DESIGN REVIEW BOARD RECOMMENDATION MEETING | CAPITOL HILL TOD

SECOND EAST DESIGN REVIEW BOARD MEETING ON OCTOBER 11, 2017

FIRST RECOMMENDATION MEETING PRIORITIES & BOARD RECOMMENDATIONS

RECOMMENDATION 2 | COMPARATIVE STREET FACADES ON BROADWAY AVE | BUILDING C

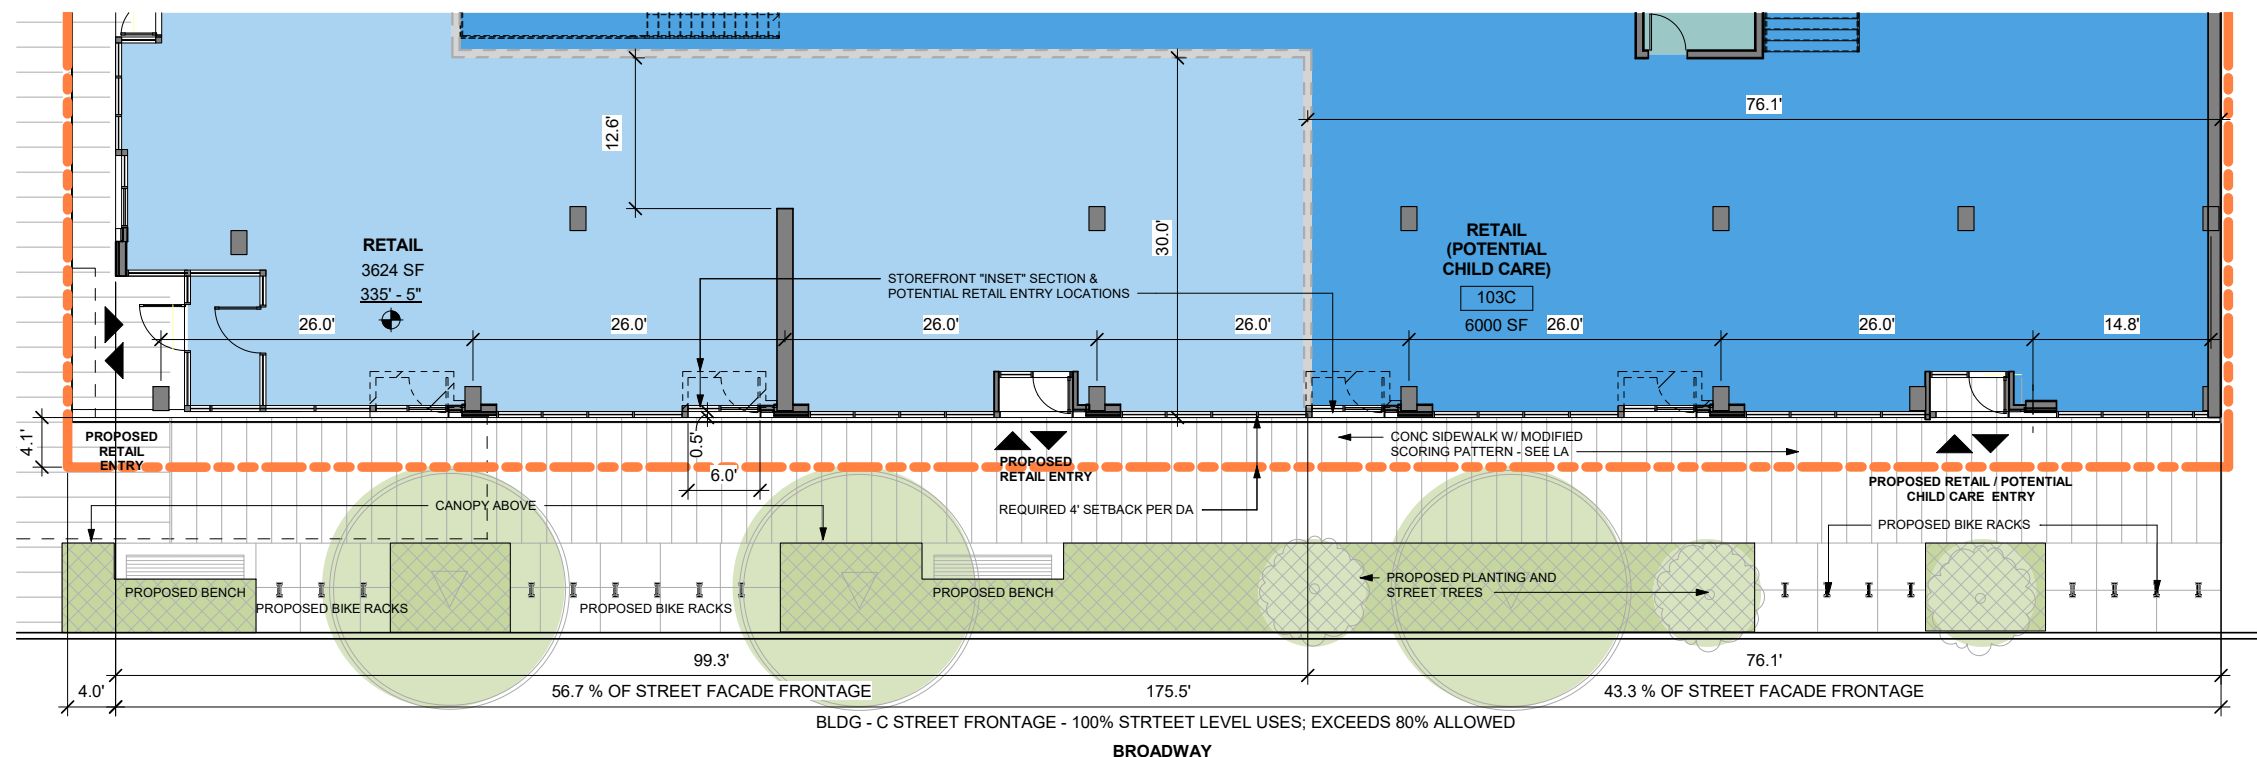
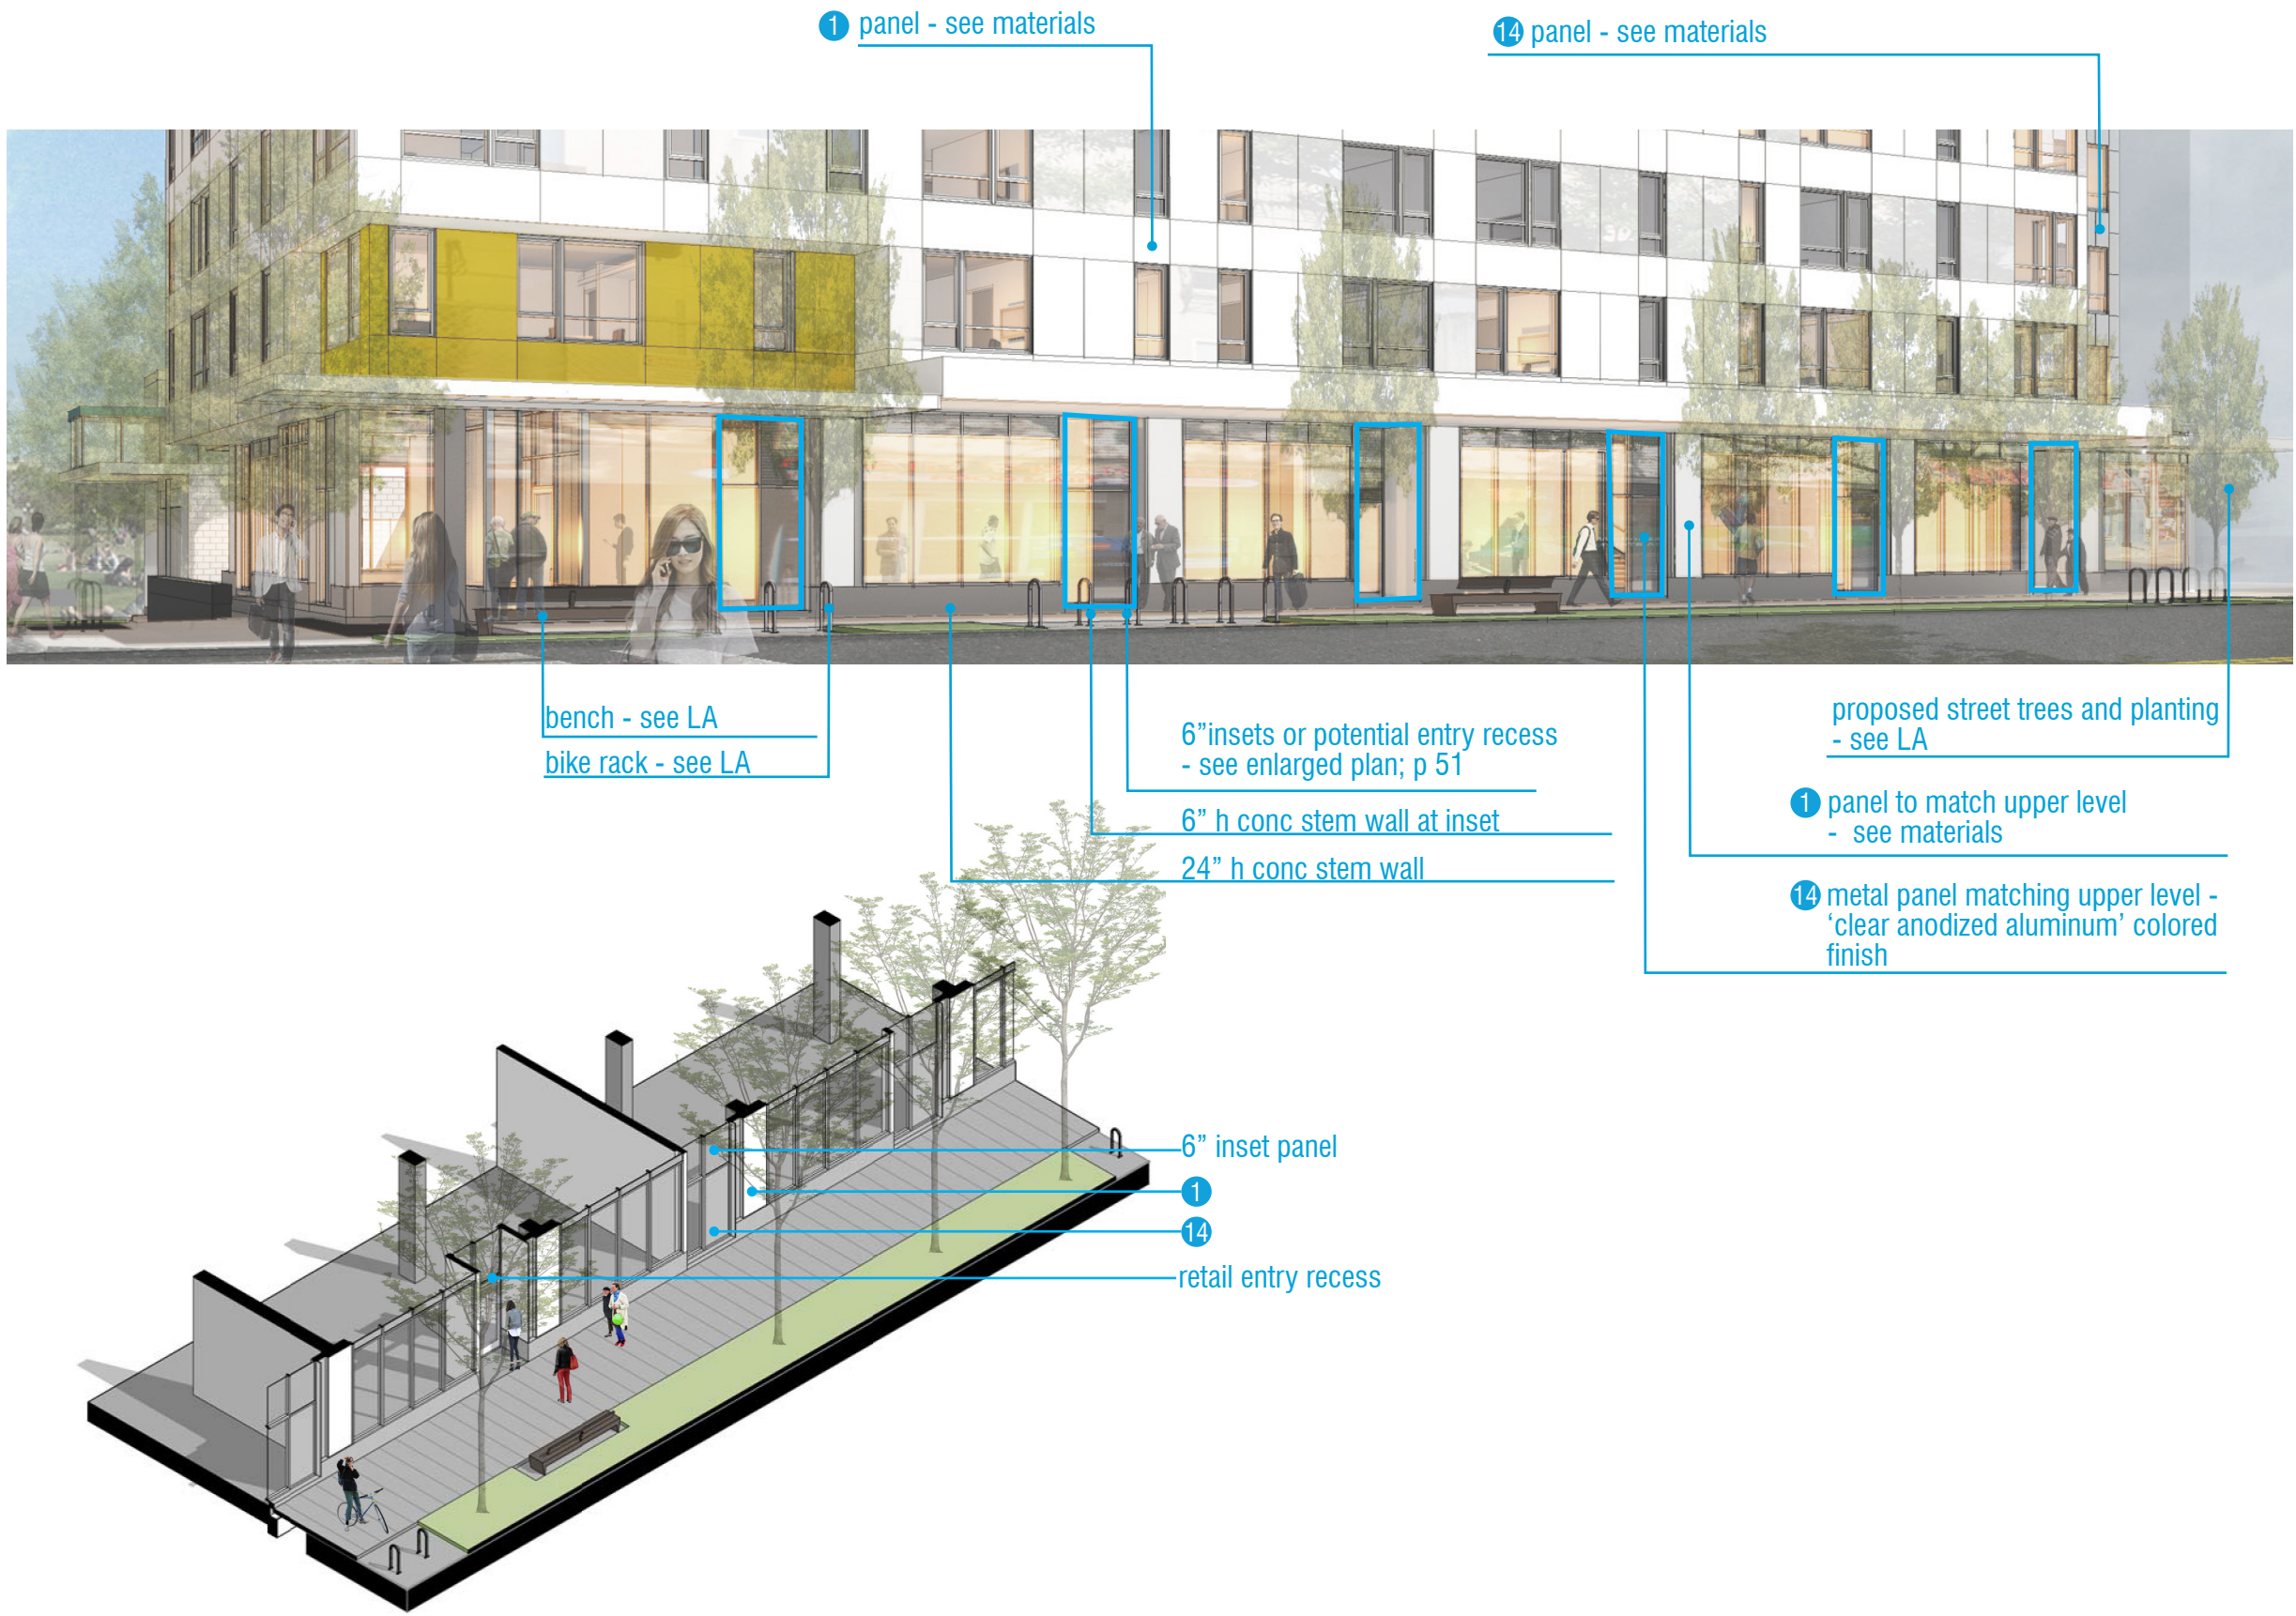
1) The Board continued to have concerns with the future potential lack of street activation of the proposed daycare use on Broadway. They recommended further minimizing this frontage and would support a departure from the commercial depth standards to help achieve this frontage activation issue. (CS2-S-I; PL3-C-1, PL3-C-2, PL3-I-iii)

The Broadway facade has been modulated with storefront along Broadway Ave by introducing bays with shallow and deeper "insets" to accommodate potential entry door locations. Additional facade materials relating to the upper levels are introduced to further add variety to the street level. The bay rhythm adding scale and character as well as the site improvements (benches, planting, additional street trees and bike racks) all help to better activate the street edge than the proposal at recommendation meeting #1. Before, the maximized transparent ribbon proposed relied more on the character of the tenant spaces. See comparative west elevations to the left.

RECOMMENDATION 2 | LEVEL L03 - L07

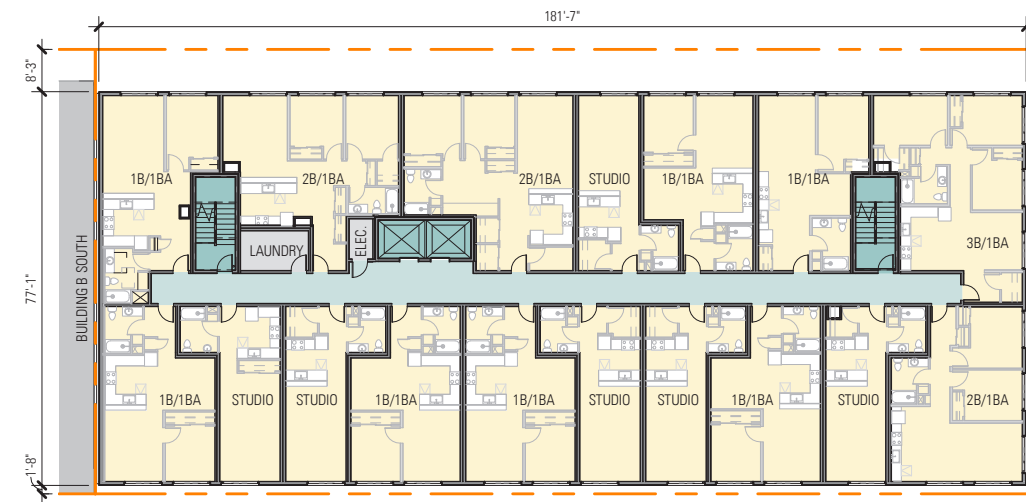
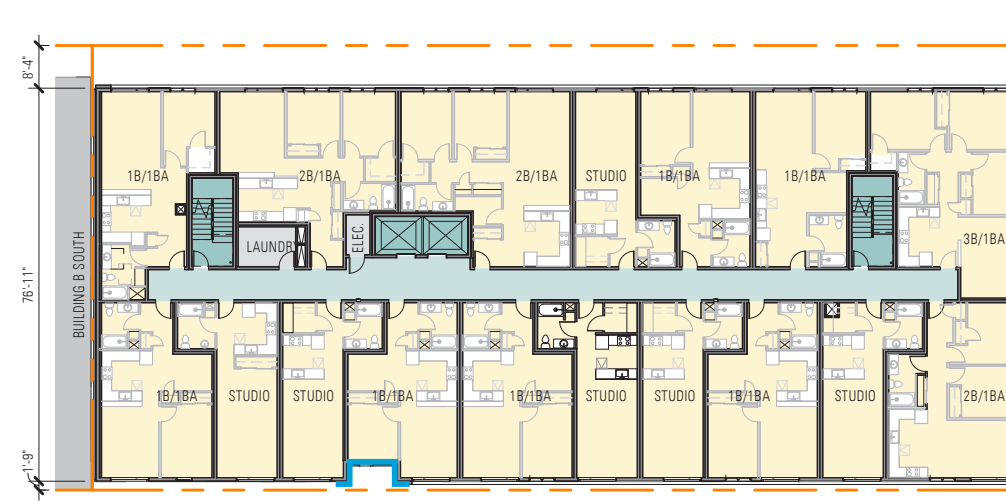
1) The Board appreciated the building height step between Buildings B North and B South, but was concerned with the overall flatness of the elevation and lack of articulation and/or special residential character. The Board suggested the use of Juliet balconies, setbacks, modulation, lanterns, etc. to emphasize the residential character and provide more texture. This direction was also reiterated at the EDG noting that other vertical notches and reveals are critical to modulate the long walls. (CS2-S-III-I; DC2-B & C & D2, DC2-S-V-iii)

Modulation has been added on the 10th Avenue facade which helps highlight the residential entry. This vertical slot is in the same plane and of the same material as the lower level; it is reminiscent to the west side of B-South and picks up on the offset windows at that location. This gap breaks down the scale of the upper portion of the building. The southern section, in close proximity to B-South, has refrained from color, but repeats the offset in the narrow windows. The northern portion is framed in white and contains the playful teal-color gradient.

The north end of the building becomes the end-cap of the frame. The wall is thicker to allow for punched openings for added modulation and interest. This treatment also occurs on the southern portion on the 10th Avenue facade.

Window size and positioning has been refined by differentiating window sizing to reflect use, as is typical in residential architecture. Smaller windows are typically located at the bedrooms to reflect the heightened desire for privacy, while larger windows are located at living areas and studios.

B-North accent color scheme

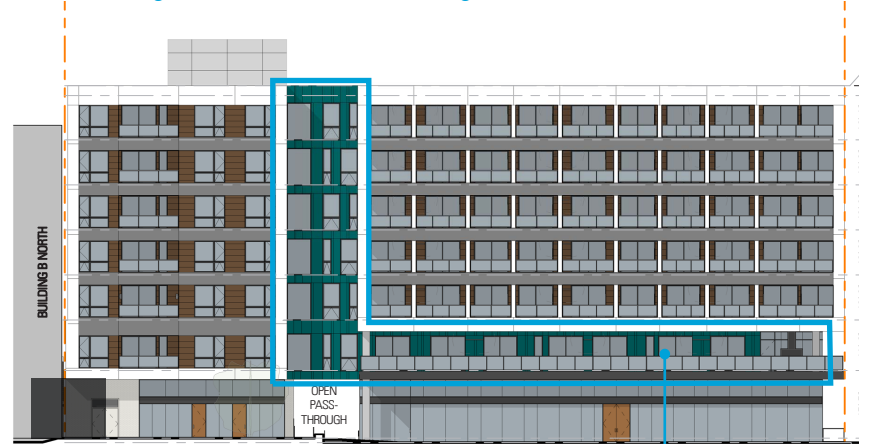
3) The Board applauded the technique of the color fade and wrapping of the color, however, they echoed public comment and were concerned that the color scheme is less timeless than the rest of the building forms and pattern found elsewhere on the development. This should be explored further. (CS2-S-III-I; DC2-B & C &D2, DC2-S-V-iii)

RESPONSE:
The chosen accent color is timeless in that it is not a ‘color of the moment’, but was carefully considered to work with the overall development. The accent color for B-North was derived from:

1. Overall scheme of A & C to use warm accent colors, indicative of the bustling Broadway, and the B buildings using cooler colors more indicative of the quieter neighboring streets.
2. At B-South, the main building materials of rich wood paneling and cement grey panels were chosen first and relate to A & C. The teal color was chosen as a complimentary color to both of these.
3. B-North is picking up on the colors of B-South, as the board is asking for it to relate more to the rest of the buildings. The teal color also gives a nod to the Holiday apartment building across 10th Ave. and the glazed CMU of the existing North station headhouse.

The teal color family of B-North relates to the metal teal accent of B-South
